Sector 3, Aiken's Village, Stepaside, Co. Dublin

Quality Audit

Ironborn Real Estate Ltd.

Project number: 60617802
PR-424832-ACM-XX-XX-RP-CE-00-0001

Figure 5.3: Proposed Steps

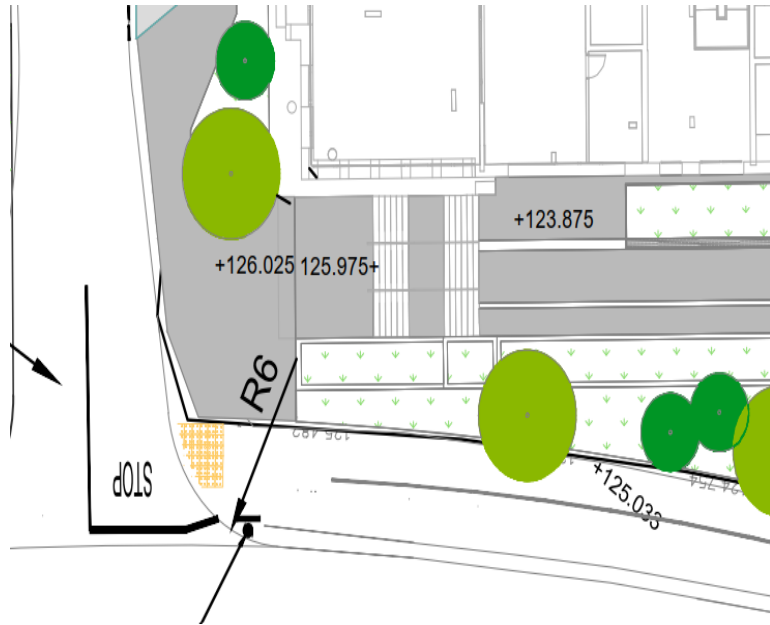
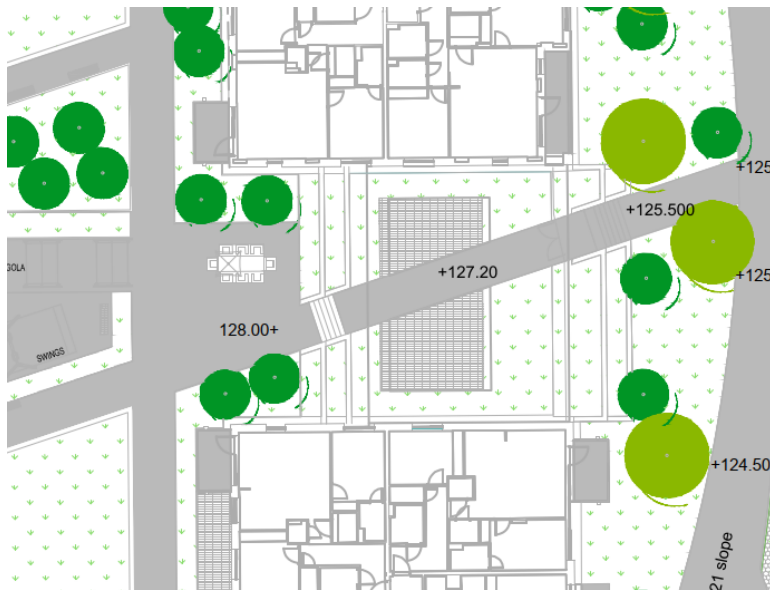
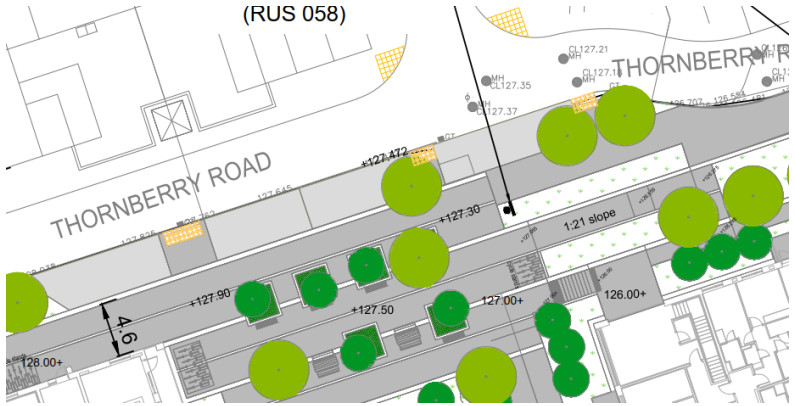
5.1.1.2 Problem	
<i>Location</i>	Throughout scheme
<i>Drawing</i>	Proposed General Arrangement
<i>Summary</i>	Steps provided without a ramp alternative

Steps are proposed at a number of locations, without the provision of an alternative means of access such as a ramp. Some people may find the steps difficult to use, such as the elderly and will result in a barrier for accessibility.

An alternative means of access should be provided, such as a ramp with appropriate gradients and handrails, in accordance with the *Building for Everyone*.

5.1.1.1	Y	Y		As part of the Detailed Design Stage, an updated topographical survey will be undertaken.	Yes
5.1.1.2	N	N		The podium areas are for the use of residents only. There is level access provided to each podium from the street between Blocks B and Block C and through Block FG. This layout has been reviewed and approved by the DAC consultant	Yes

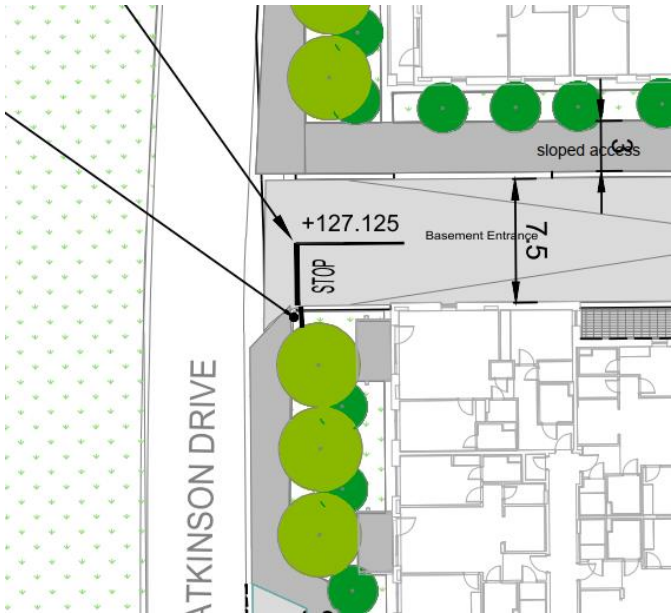
5.1.1.3 Problem		 <p style="text-align: center;">Figure 5.5: Proposed Tactile Paving</p>
Location	Thornberry Road	
Drawing	Proposed General Arrangement	
Summary	No tactile paving on northern side of crossing	
Description		<p>Tactile paving is proposed Thornberry Road on the southern side, but there isn't a corresponding dropped kerb or tactile paving on the northern side. This may result in a trip hazard, in particular to the visually impaired, or resulting in accessibility issues for people using wheelchairs.</p> <p>Recommendation:</p> <p>Appropriate dropped kerbs and tactile paving should be provided on the northern side of the road carriageway.</p>

5.1.1.3	Y	Y		Tactiles are in place on opposite side of the road and drawings have been updated. Any modifications needed to the tactiles on the northern side will be agreed at Detailed Design stage with DLRCC	Yes
